UNITED STATES PATENT AND TRADEMARK OFFICE

APPLICATION NO.	FILING DATE	FIRST NAMED INVENTOR	ATTORNEY DOCKET NO.	CONFIRMATION NO.
10/553,024	08/29/2006	Nikolai Filimonov	9342-346	6690

Office Action Summary

DETAILED ACTION

Figure 1 of Aihara.

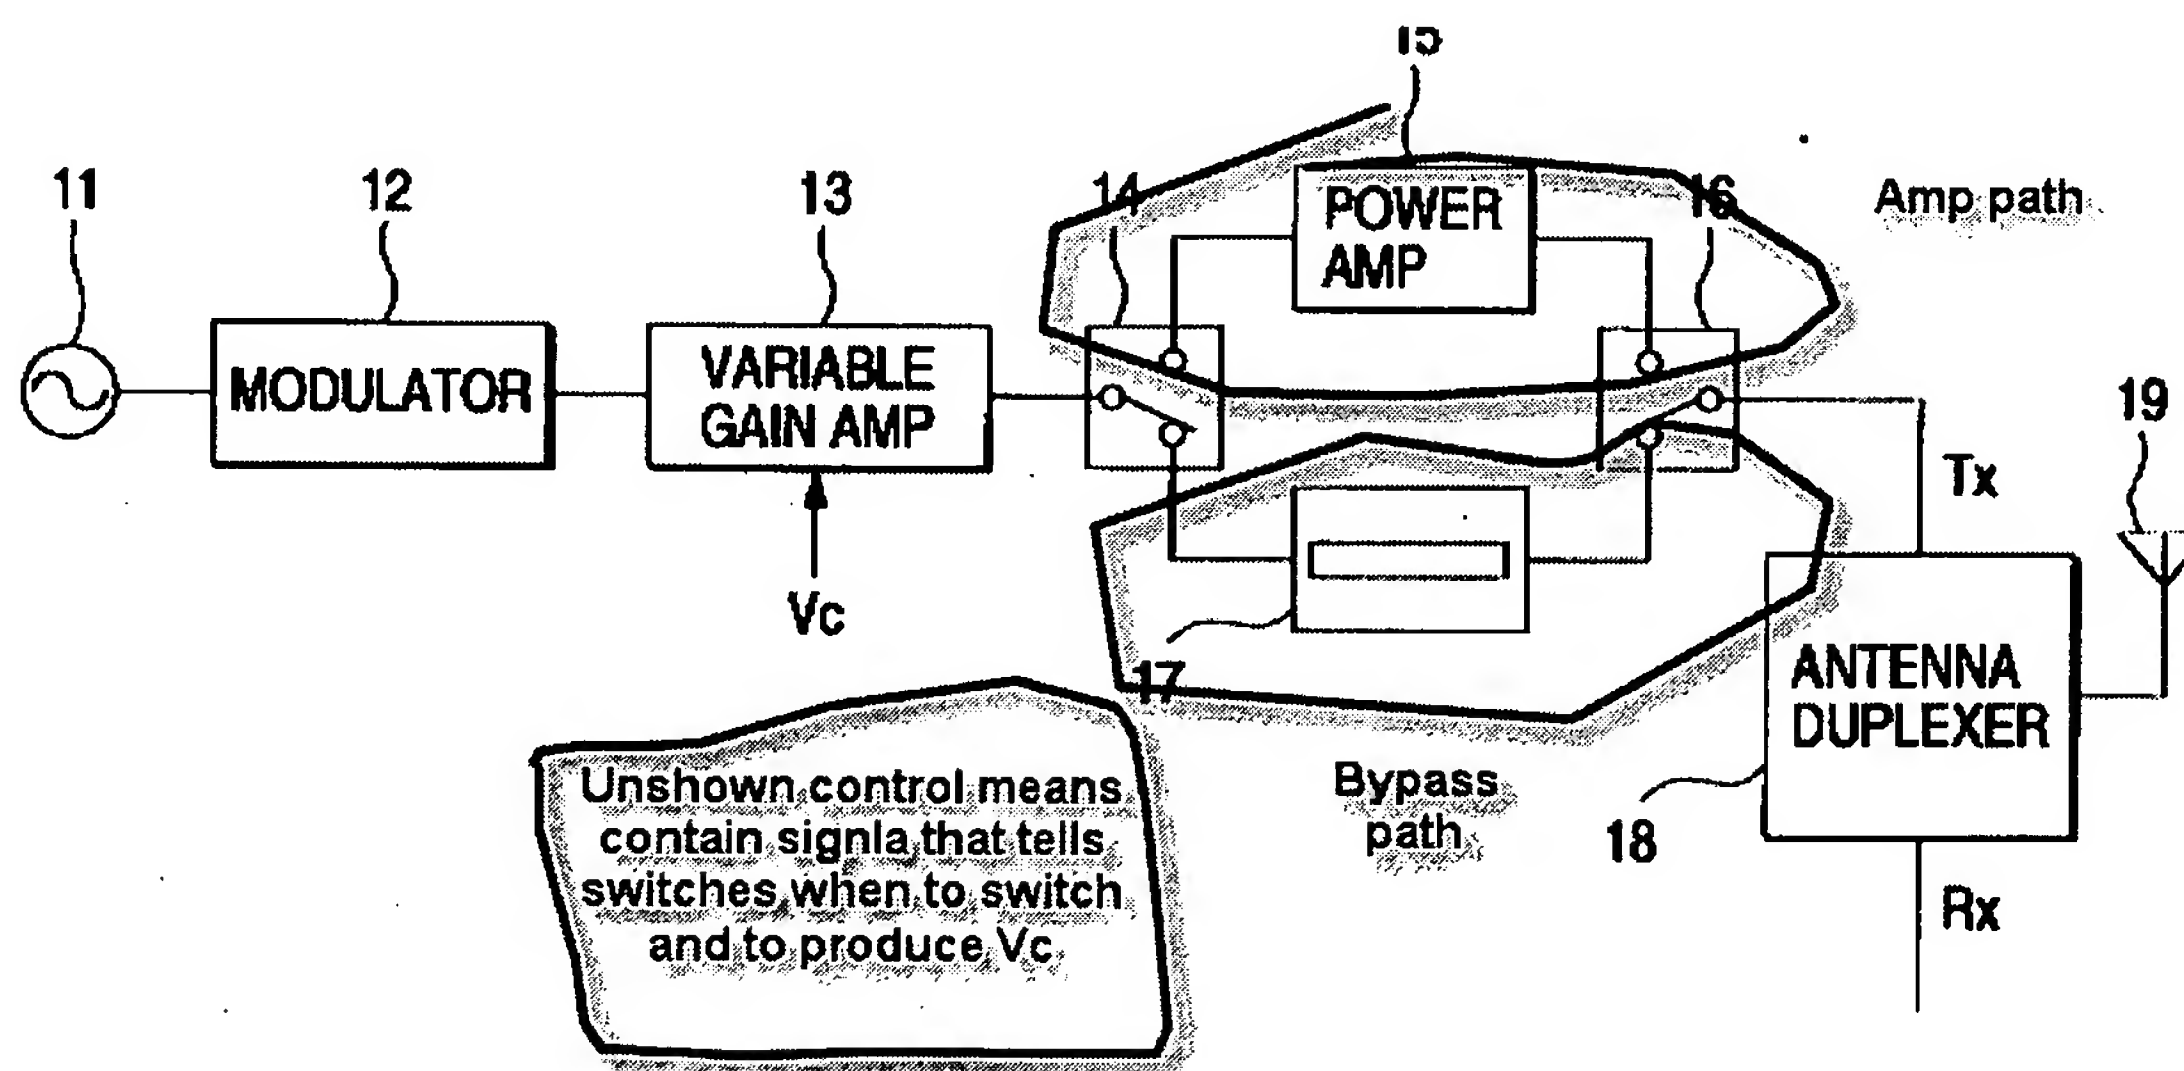
Figures 1, 3, 4, 5, 6 and 7 as well as the relevant text of Aihara discloses the basis invention set forth by the claims. Rather than describe each and every Figure of Aihara that meets the claims in detail, the examiner in the interest of being concise will only use exemplary Figure 1 of Aihara to describe how the claimed invention is met by the prior art. Similar reasoning does apply to the other Figures of Aihara. Clearly, the circuit of provides for the step of amplifying an RF signal by the use of a power amplifier arrangement. As shown above there is an input terminal that supplies an input signal, an output terminal that outputs an RF signal, an amplification path that amplifies, a bypass path that bypasses, an a delay

control means that while is unshown is clearly present in Aihara so as to control the switches 14 and 16 and the variable amplifier 13 that “pre-amplifies” the input RF signal. Aihara inherently has such a “delay control means” for there must be something that provides the signal for the switching and the amount of variable gain to be chosen or selected. Thus there is a control terminal, i.e. node that controls the operation of the amplification path and the bypass path. It then goes without saying that this control terminal, i.e. node, will be “configured” such that it controls the operation of the variable gain amplifier, the amplification path and the bypass path in combination to select the particular power level i.e. state.

The PCT search report of record states that the claim language that specifically recites the “inverse state” is unclear. The examiner respectfully disagrees for even though the specification fails to specifically define the inverse of the first or second state depending on the claim, when there is no specific limiting definition in the specification MPEP 2111.01 is absolutely clear that the plain meaning must be given to the terms in the claim. Thus looking at claim 1 for example the first state corresponds to a particular energy level recited as “power specified”. Well, the inverse of this first state can only be exactly equal to one divided over the “power specified” for this is what the inverse of the first state is. For example lets say that the first state is five(5) Watts then the inverse of five(5) Watts would be one over five(5) Watts or a fifth of a Watt (5th Watt). The examiner just does not see how the PCT search report can even state that these claims are unclear when it is absolutely perfectly clear that the power level that defines one state has to be exactly the inverse of the other power level that defines another state. Alh, however, is silent on saying that the one power level i.e. one state, is the inverse of the other. The examiner does not see how this could possibly patentably define over the prior art because this is merely setting forth how much attenuation is desired in the by-pass path. It is merely the selection of the optimum or workable range that has been long held to involve but routine skill in the art.

It would have been obvious to one having ordinary skill in the art at the time the invention was made to have one state the inverse of the other state, since it has been held that where the general conditions of a claim are disclosed in the prior art, discovering the optimum or workable ranges involves only routine skill in the art. In re Aller, 105, USPQ 233.
